Product Change Notice (PCN)

PCN Number: PCN-0450005R-01

Product(s) Affected: MJ-3536N

PREVIOUS CUI DEVICES DETAIL / IMAGE	NEW CUI DEVICES DETAIL / IMAGE

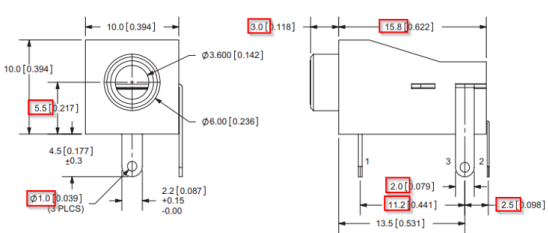
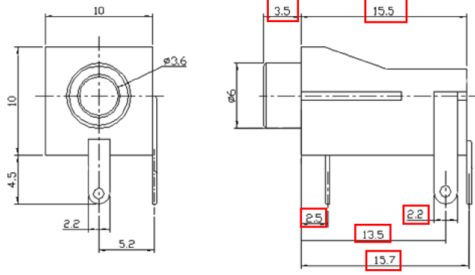
Description of Change: mechanical and material differences as shown below:

<p style="text-align: center;">PCB LAYOUT TOP VIEW</p>	 <p style="text-align: center;">Recommended PCB Layout Top View</p>																																				
<table border="1"> <thead> <tr> <th></th> <th>MATERIAL</th> <th>PLATING</th> </tr> </thead> <tbody> <tr> <td>terminal 1</td> <td>brass</td> <td>tin</td> </tr> <tr> <td>terminal 2</td> <td>copper alloy</td> <td>tin</td> </tr> <tr> <td>terminal 3</td> <td>brass</td> <td>tin</td> </tr> <tr> <td>bushing</td> <td>brass</td> <td>nickel</td> </tr> <tr> <td>plastic</td> <td>PBT</td> <td></td> </tr> </tbody> </table>		MATERIAL	PLATING	terminal 1	brass	tin	terminal 2	copper alloy	tin	terminal 3	brass	tin	bushing	brass	nickel	plastic	PBT		<table border="1"> <thead> <tr> <th>DESCRIPTION</th> <th>MATERIAL</th> <th>PLATING/COLOR</th> </tr> </thead> <tbody> <tr> <td>terminal 1</td> <td>brass</td> <td>silver</td> </tr> <tr> <td>terminal 2</td> <td>brass</td> <td>silver</td> </tr> <tr> <td>terminal 3</td> <td>brass</td> <td>silver</td> </tr> <tr> <td>bushing</td> <td>brass</td> <td>tin</td> </tr> <tr> <td>housing</td> <td>PA (UL94V-0)</td> <td>black</td> </tr> </tbody> </table>	DESCRIPTION	MATERIAL	PLATING/COLOR	terminal 1	brass	silver	terminal 2	brass	silver	terminal 3	brass	silver	bushing	brass	tin	housing	PA (UL94V-0)	black

MATERIAL	PLATING																																			
terminal 1	brass	tin																																			
terminal 2	copper alloy	tin																																			
terminal 3	brass	tin																																			
bushing	brass	nickel																																			
plastic	PBT																																				
DESCRIPTION	MATERIAL	PLATING/COLOR																																			
terminal 1	brass	silver																																			
terminal 2	brass	silver																																			
terminal 3	brass	silver																																			
bushing	brass	tin																																			
housing	PA (UL94V-0)	black
